Following is a brief on our internal analysis on the issue mentioned to you

Few items which are under suspicion based on our analysis are as below:

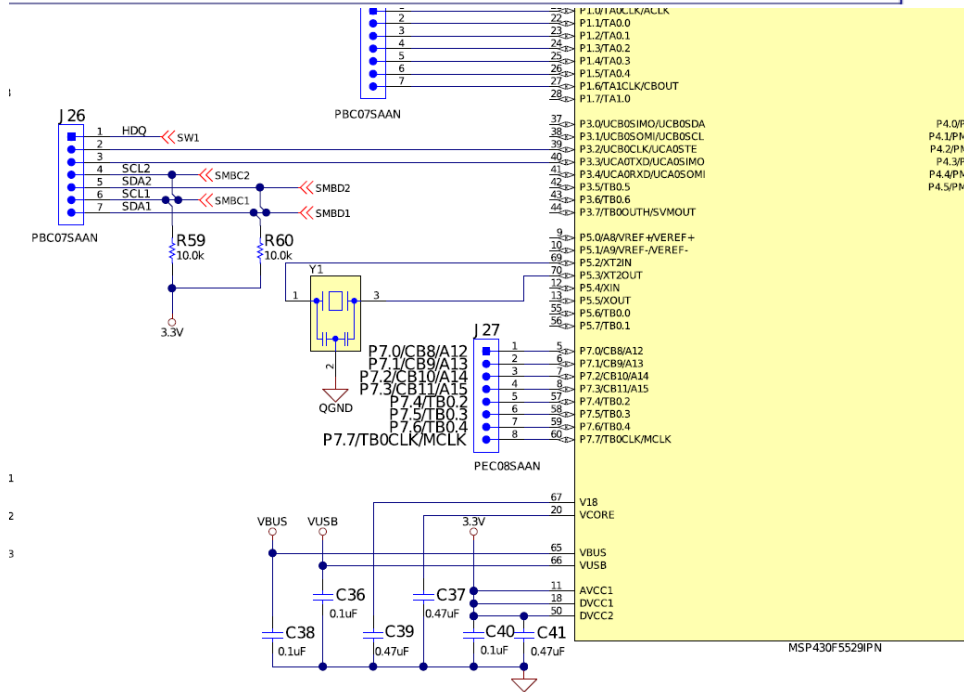
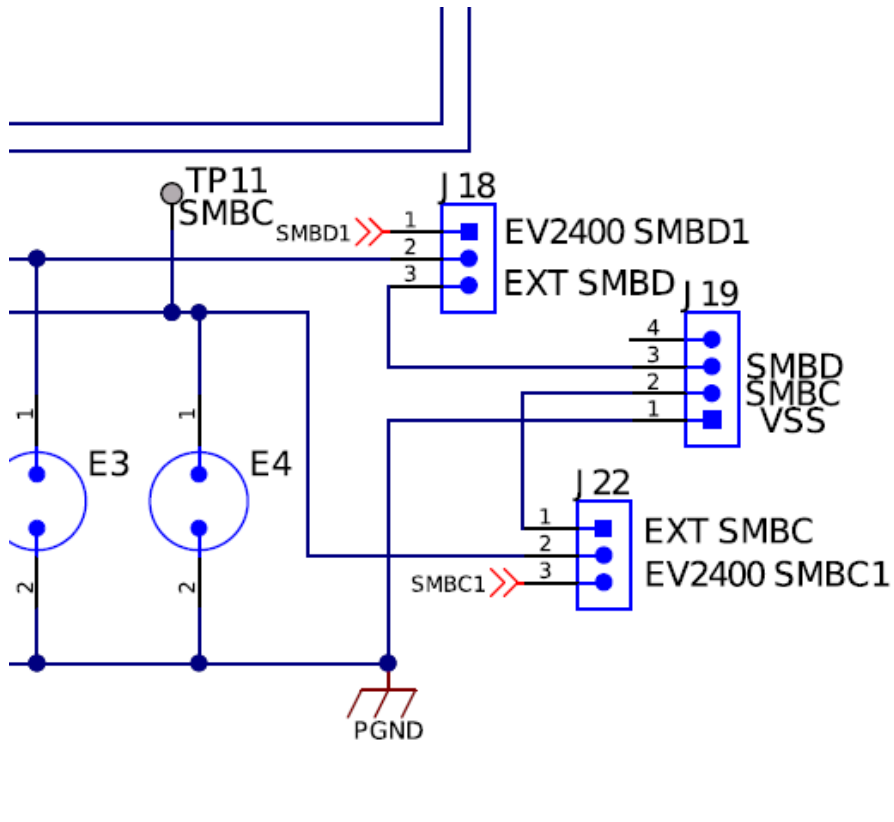
It's unclear whether this SMBus interface can even be directly interfaced with a 3.3V level I2C chipset or no. However, on looking at eval kit below, the SMBus of the BMS chip does interface directly with the 3.3V TI controller whilst having 3.3V pull ups on both the pins.

This is exactly how we were using the eval kits setup at our end by shorting pins 1 and 2 of J18 and J22. They did not burn yet in this setup though.

It's a discrepancy right now to understand if this could be any issue since the board burnout isn't consistent.
